AERONAUTICAL CHARTING FORUM
Charting Group
Meeting 17-02 – October 25 - 27, 2017

RECOMMENDATION DOCUMENT

FAA Control # ACF-CG RD 17-02-318

Charting for helicopter routes designed to meet Navigation Specification Required Navigation Performance (RNP) (NAVSPEC) 0.3.

Example:

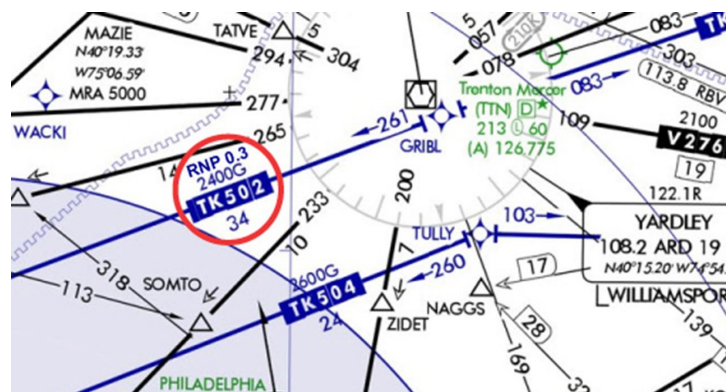
Add "RNP 0.3" to helicopter route information on Enroute instrument charts.

Mike Webb, FAA/AFS-420, [briefed the issue](#). Mike stated that in the recent publication of Advisory Circular 90-105A a new Navigation Specification (NAVSPEC) was defined for helicopters. It will be applied solely to helicopters using GPS and with avionics capable of RNP 0.3 accuracy. Mike is recommending that for the enroute application, an RNP 0.3 indicator be added to low altitude helicopter TK routes where applicable. He pointed out that there is already a field for RNP values on FAA Airway Form 8260.16.

Ted Thompson, Jeppesen, stated that internationally, they have charted RNP values on airway identifiers. It was determined that this was insufficient and that they should be charting them on waypoints at the beginnings and ends of the relevant segments. This resulted in pilot confusion. They then decided to take them off the charts entirely and only store the NAVSPEC in the database. Ted did acknowledge that there is a need to label the narrowing of the airway and he suggested the possibility of depicting the NAVSPEC as an equipment note for the airway.

John Moore, Jeppesen, asked if all TK routes will be RNP 0.3. Mike said that the 0.3 would be an exception to the standard. He suggested a charting option to explain the standard RNP value for TK routes on chart legends and in the AIM and then chart on routes only those that are an exception. A potential confusion was voiced that this may become very complicated if the RNP values vary by segment. Mike stated that if a route is RNP 0.3, it is RNP 0.3 for the entire extent of the route and would not vary by segment.

Rich Boll, NBAA, asked if an RNP 0.3 route will be stripped from the aircraft’s database if they don’t have the capability to fly it. If it’s not extractable from the database this doesn’t work. John Collins, Foreflight, stated that the flight plan can be used to exclude a pilot from flying a procedure they aren’t capable of. Rune Duke, AOPA, added that you could be cleared to fly a route that you did not file for. He asked if the controller would be aware that a given aircraft could not fly that route. Bennie Hutto, NATCA, said ATC does not know what the aircraft is qualified for. Rune said that in that case, he believes that RNP values need to be charted.
